Solver[®]
BULLETIN

Clunking noise from under vehicle

Dodge Dakota and Durango 1997-2004;
Jeep Wrangler 2000-2006

MOOG® K80244 Sway Bar Link

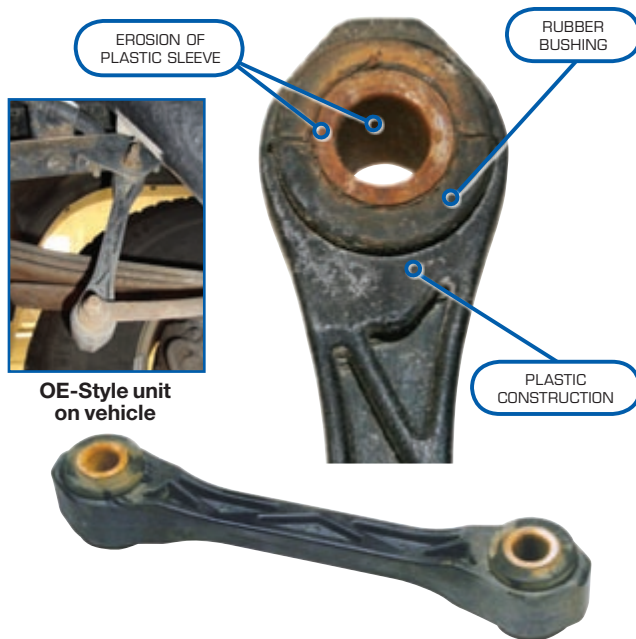
Clunking noise from underneath rear of vehicle

When going over bumps or washboard surfaces, drivers of Jeep Wranglers, Dodge Dakotas and Dodge Durangos may experience clunking and/or banging noise from underneath the rear of the vehicle. The cause is failure of the rear sway bar link. The OE-style link is prone to failure on these vehicles, especially in northern climates where more salt, road grit and grime are present. These contaminants can get into the bushing and erode the plastic sleeve, causing it to elongate and become loose, which creates noise.

The MOOG K80244 Sway Bar Link was designed for ease of installation and long life.

- Phosphate-coated, all metal design improves strength and durability.
- Thermoplastic bushings reduce noise, add strength and resist wear, salt, road grime and oils better than typical rubber bushings. In addition, they are less prone to splitting.
